Subject: EPA Comments on Alliant Energy, WI Power & Light Co -Nelson Dewey
Generating Station, Cassville, WI
Round 10 Draft Assessment Report

RE: Comment Request on Coal Ash Site Assessment Round 10 Draft Report - Alliant Energy Stations

**Re: Response to Draft Assessment Report
Nelson Dewey Generating Station**

Response
USEPA Draft Report
Safety of Coal Combustion Waste Ponds
Nelson Dewey Generating Station

FIGURE 2
Strength of Granular Materials
Nelson Dewey Generating Station

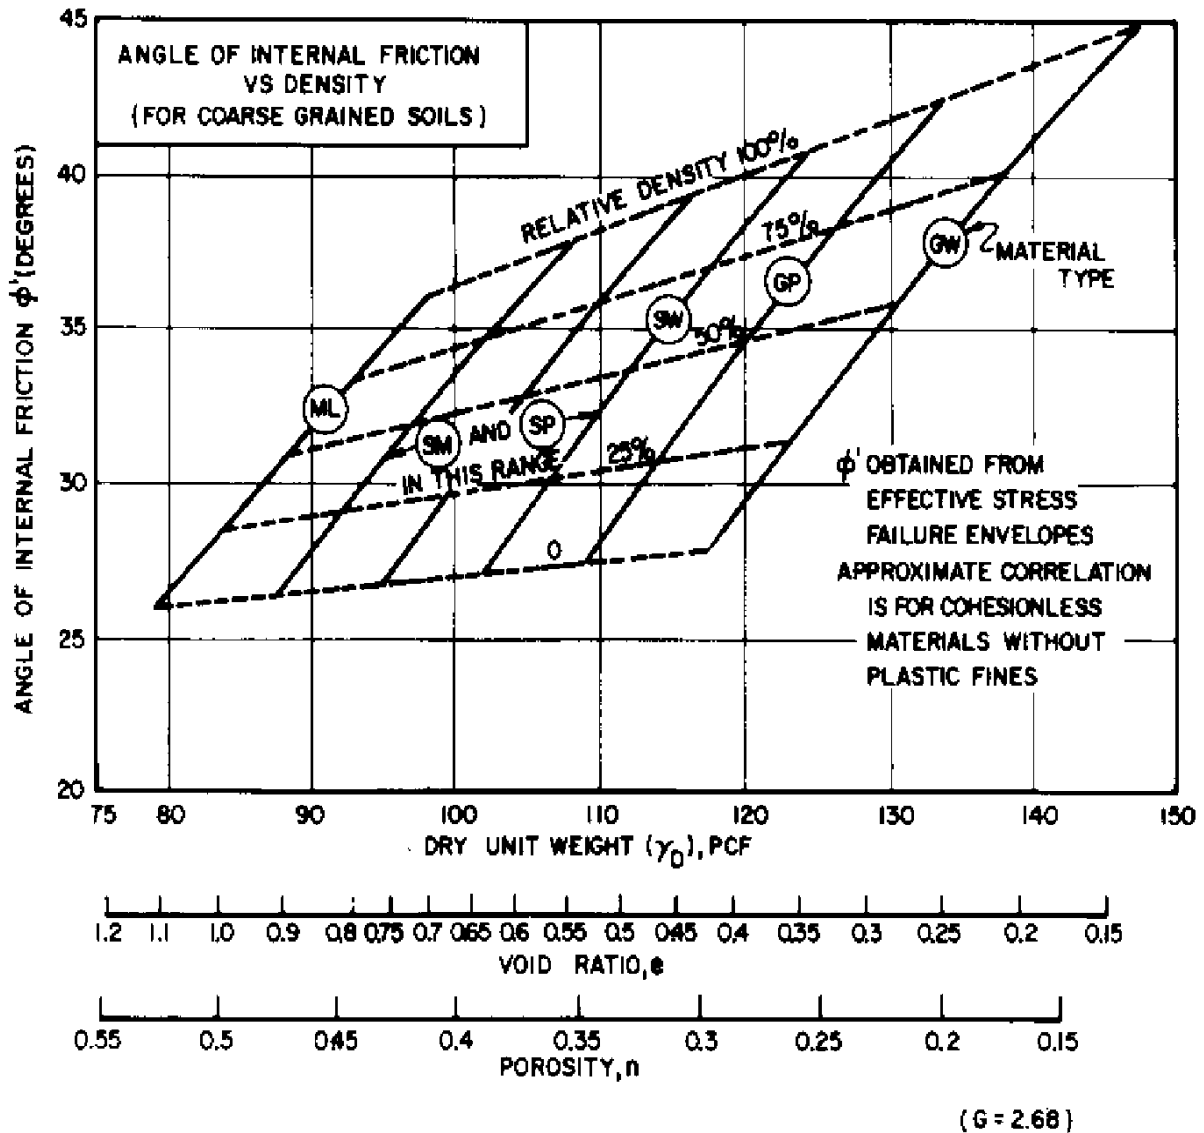
The additional soils information from 2007 supports a conclusion that the WPDES Pond was constructed by excavating into the native soils partially incising the pond and using the excavated soil to build the dikes. Figure 2 shows Figure 7 of NAVFAC DM-7.01, 1986, relating the relative density of cohesionless soils to their internal friction angle. For very loose to loose relative density ML and SM soils, the internal friction angle varies from 27 to 29 degrees. For coarser sand, as is found at the Slag Pond, a loose relative density equates to 28 to 31 degrees. The lower value of each range is used in the new analysis attached hereto (Attachments C, D & E).

**WPDES Pond Slope Stability Analyses
Potential Failure Surfaces Analyzed
Nelson Dewey Generating Station**

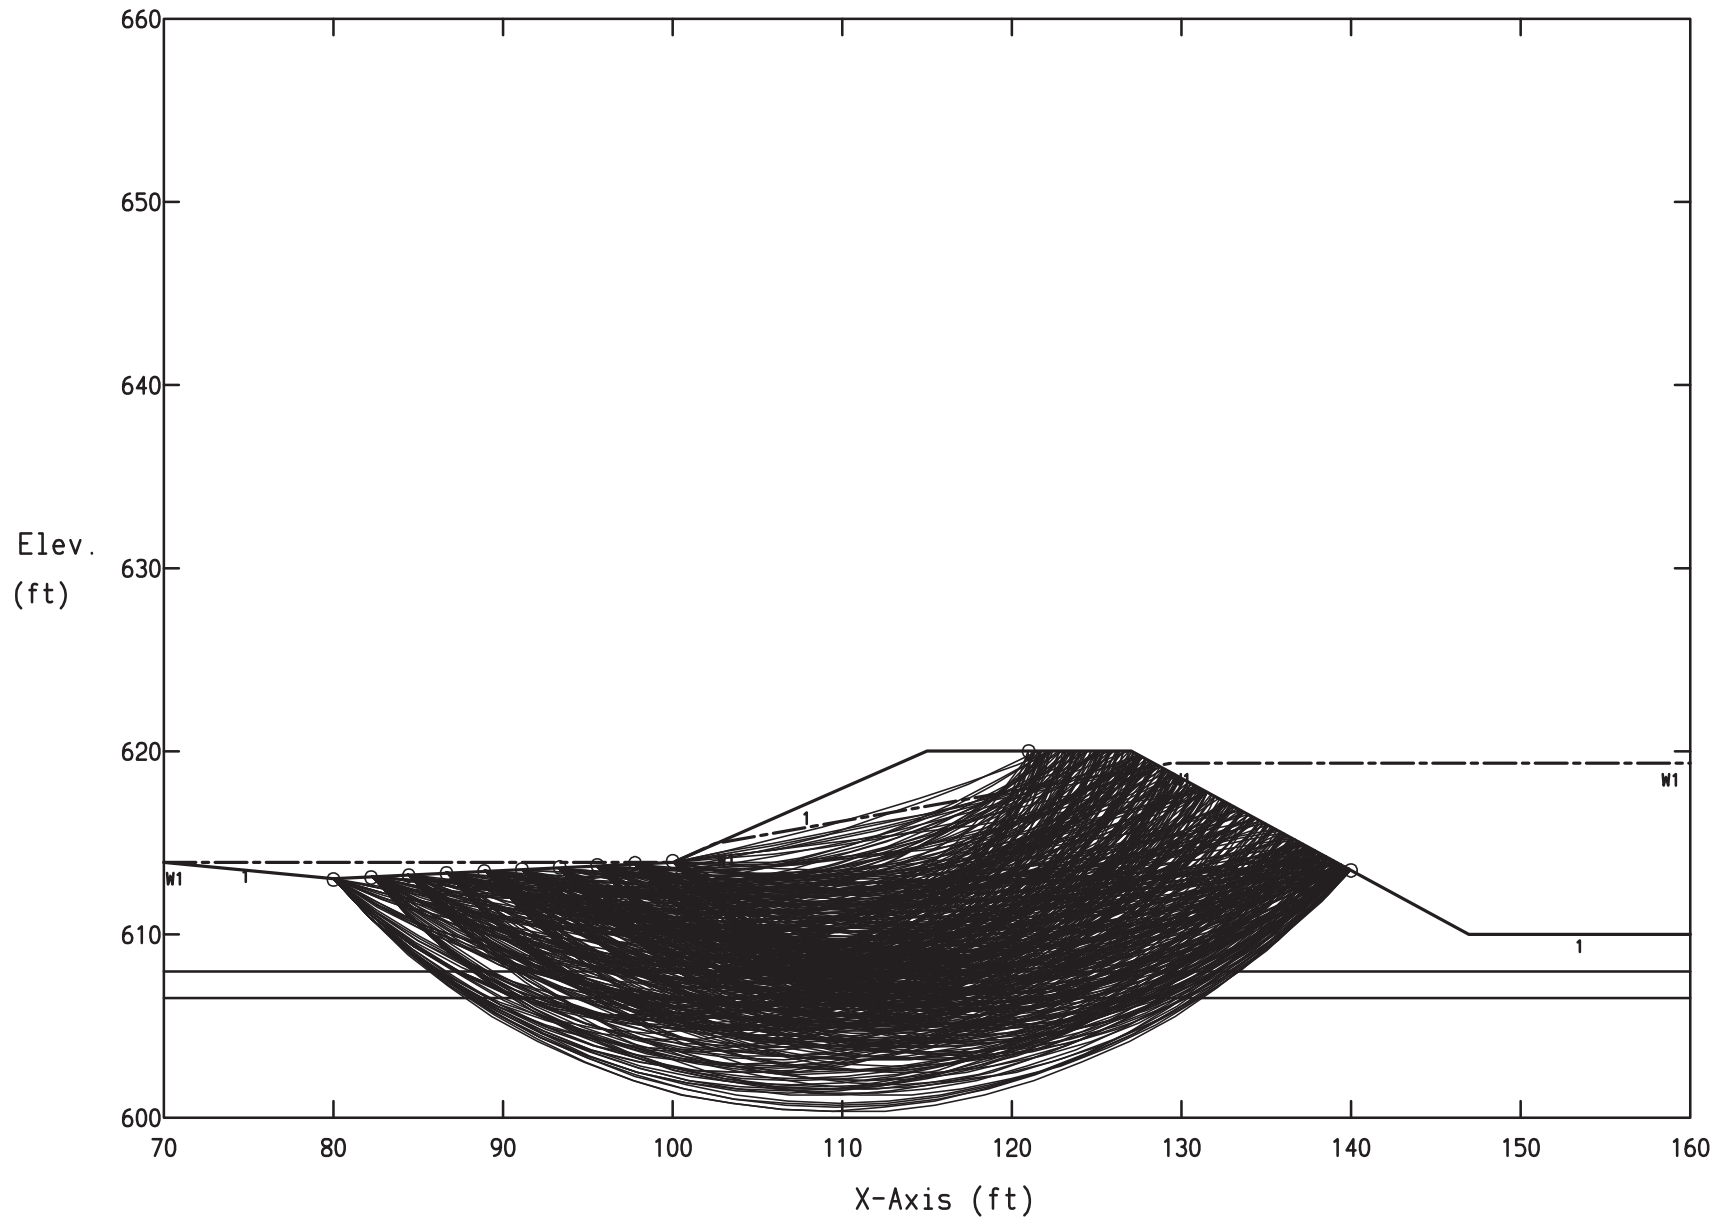
The failure surface search routine intersected the clay layer (Attachment C) but, the layer does not control the critical slope stability of the WPDES Pond. The layer would have to respond as a soft clay to have a potential impact to the stability of the embankment.

**WPDES Pond Slope Stability Analyses Results
Ten Most Critical Surfaces Per Analysis
Nelson Dewey Generating Station**

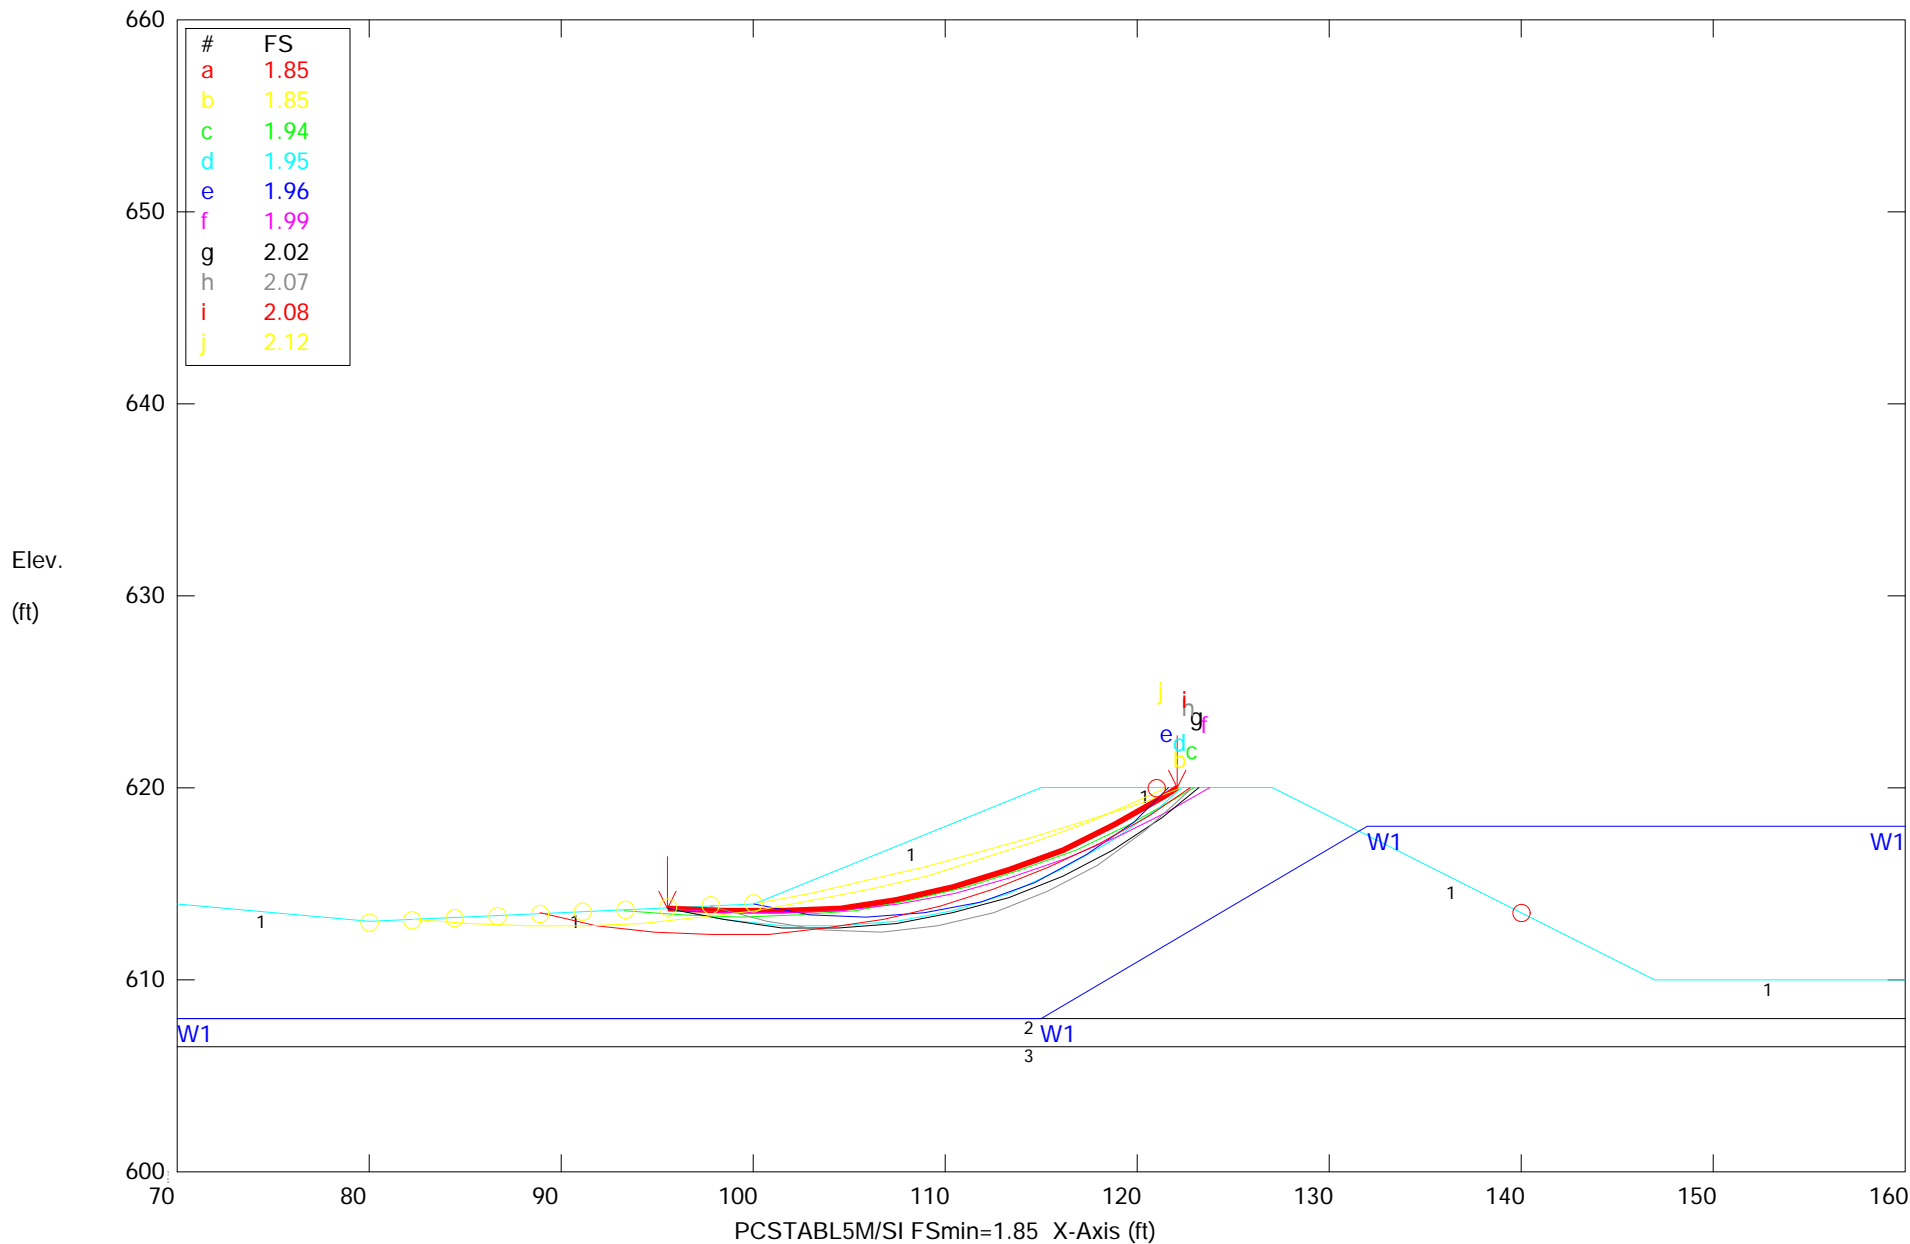
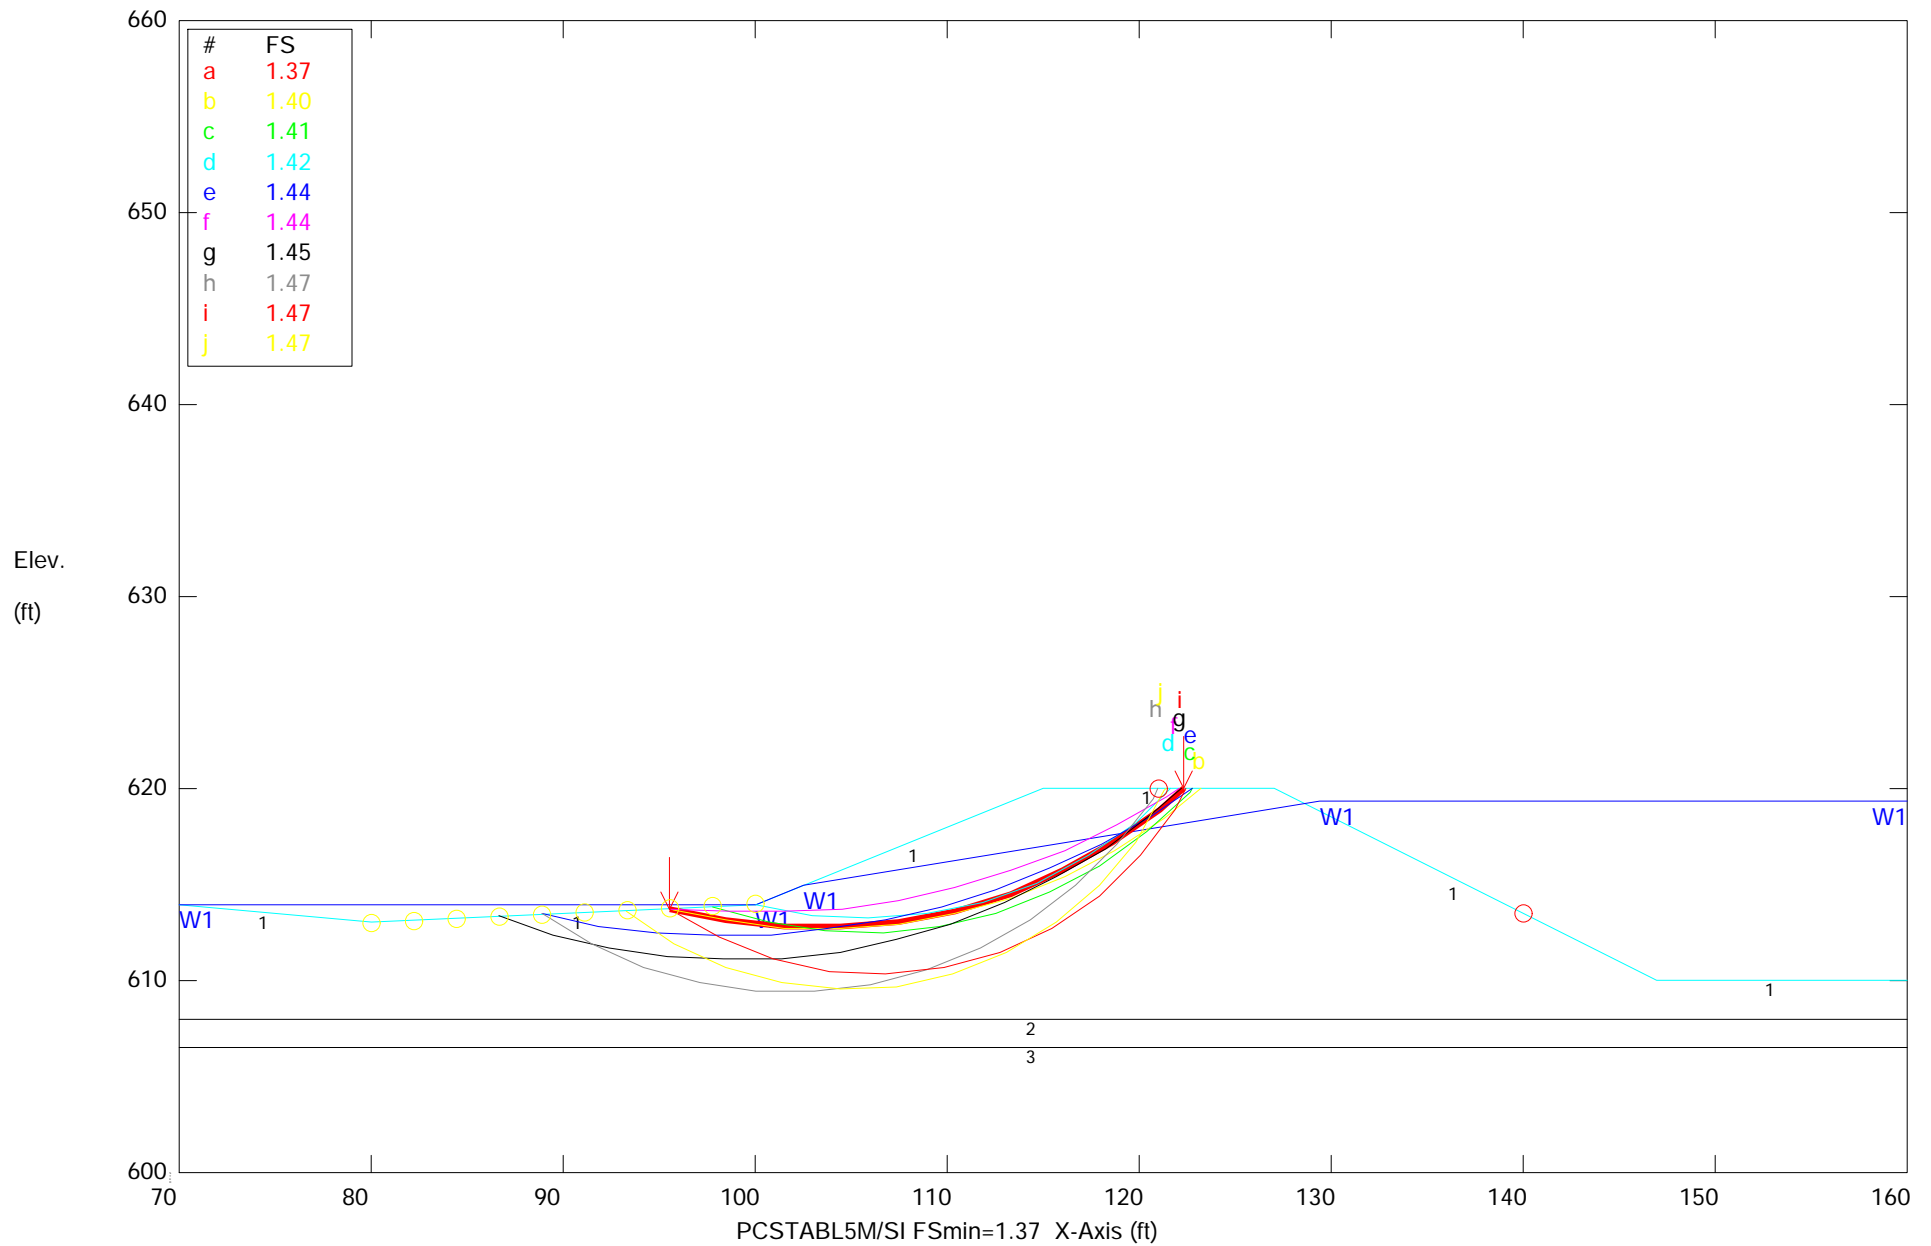
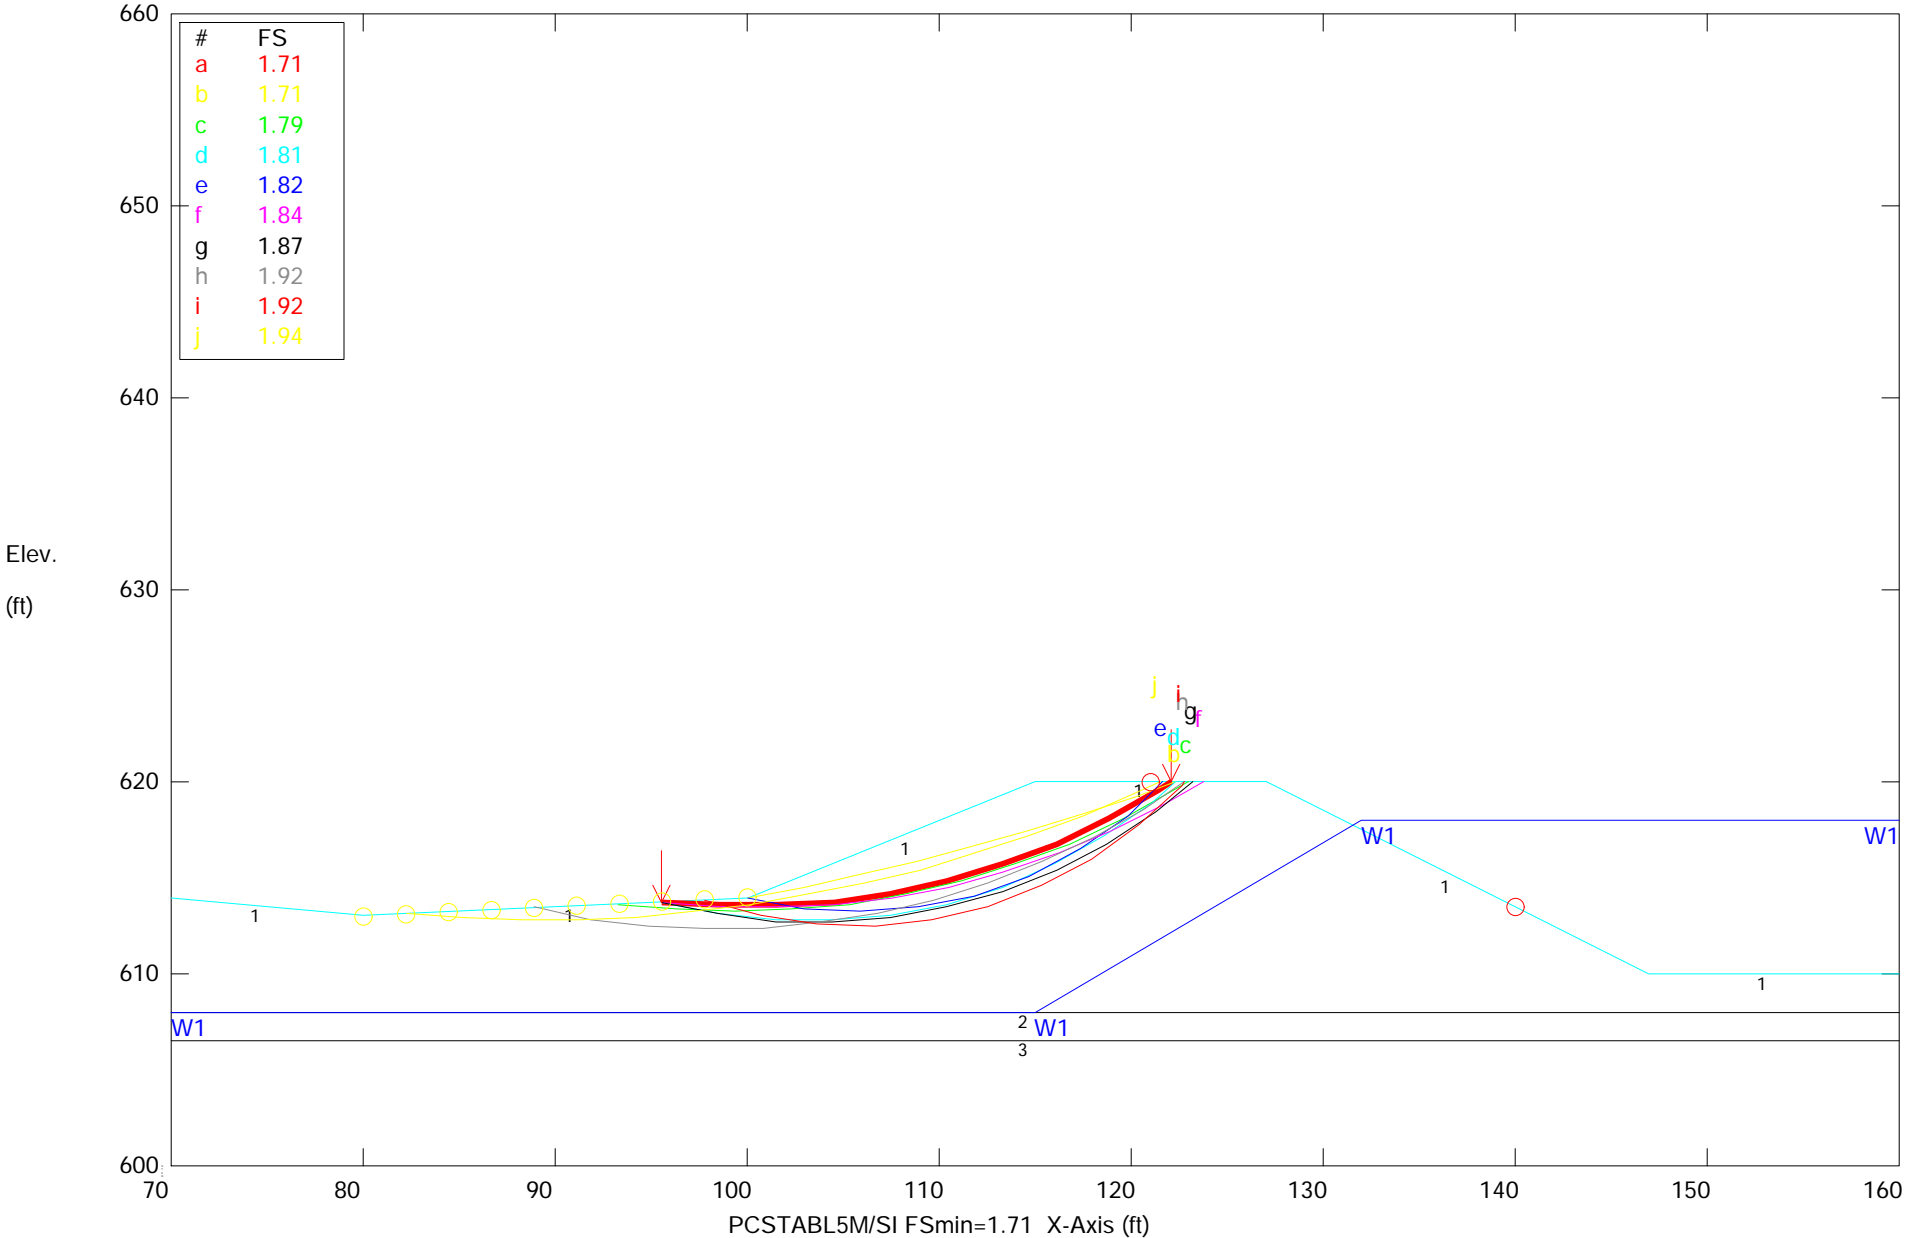
In addition to the adjustment of the soil strengths based on the URS 2007 borings, the Aether analysis¹ was also modified to show the static analysis of the WPDES Pond with water seeping vertically to the ground water surface approximately 10-feet below the normal highest operating water surface. For the Slag Pond, the static factor of safety was based on the potential failure of the inboard slope with the ground water elevation the same as the Slag Pond water elevation. For normal water levels, the WPDES Pond has a static slope stability factor of safety of 1.9, Attachment D, and the Slag Pond has a static factor of safety of 2.2, Attachment E.

For high water in the WPDES Pond (elevation 619.3 feet), the water surface at the toe of the embankment was assigned to the ground surface (elevation 614 feet) to maximize the seepage forces and cause the lowest factor of safety. Under this rapid loading condition combined with the new lower strength values the factor of safety is 1.4, Attachment D. Since this is similar to rapid drawdown the value is acceptable. For the Slag Pond, the high water condition is most analogous to rapid drawdown as the flow out of the pond to the Mississippi river would be rapid as the river stage lowers after a 100-year return flow. For rapid drawdown from the 100-year flood elevation to the bottom of the pond, the factor of safety is 1.8, Attachment E.

Finally, a new analysis of each pond with normal water elevation and the design earthquake as a pseudostatic load shows a factor of safety of 1.7 and 2.0 for the WPDES and Slag Ponds, respectively (Attachment D & E).
